# Beam Interlock System CIBU Connection Review

Christophe Martin  
TE/MPE

30/01/2015

# SPS CIBU CONNECTION STATUS : 100% OF CIBU TESTED AMONG 43

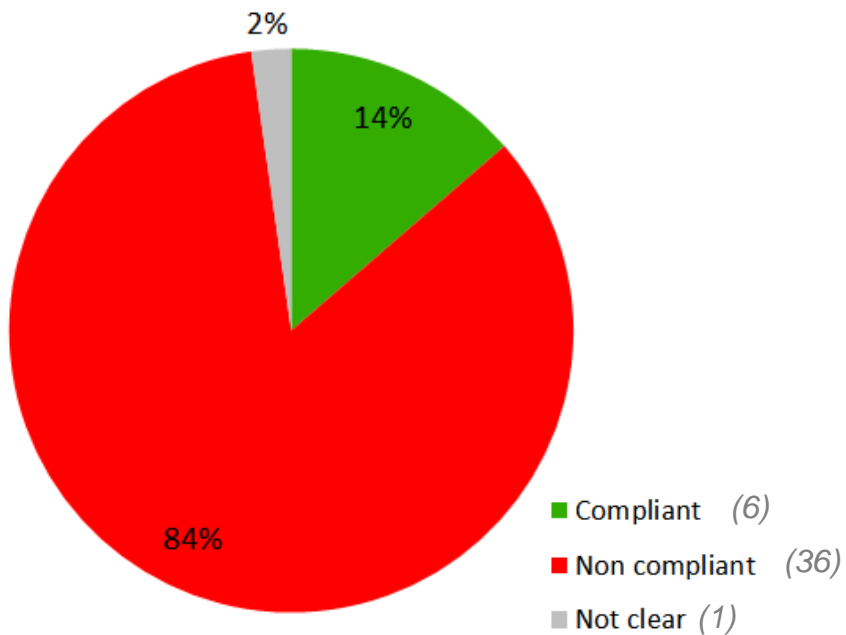
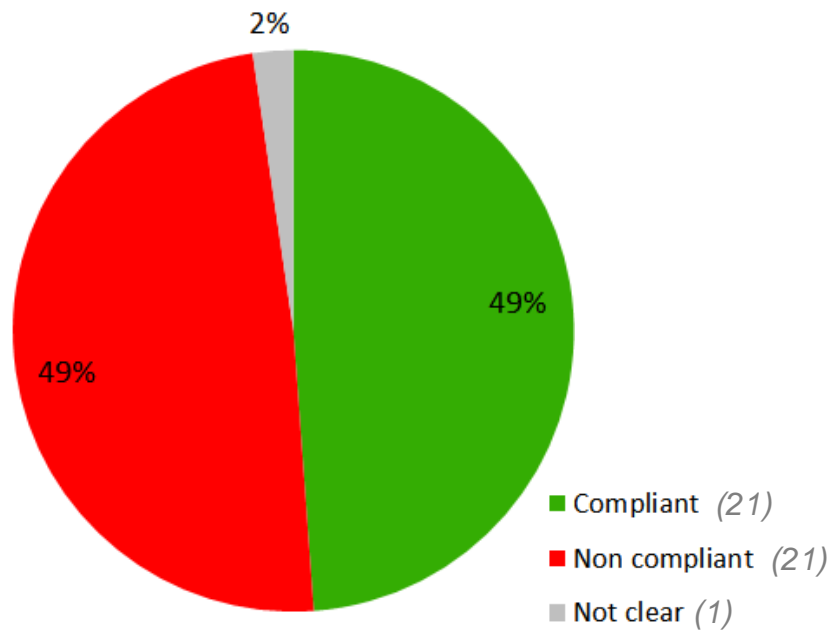
Not clear :

- The user is not present (remote test with the CCC)
- No way to test Permit A & B separately (distinct, parallel, serial ?)
- No schematic
- No GND (commissioning device need a reference point ...)
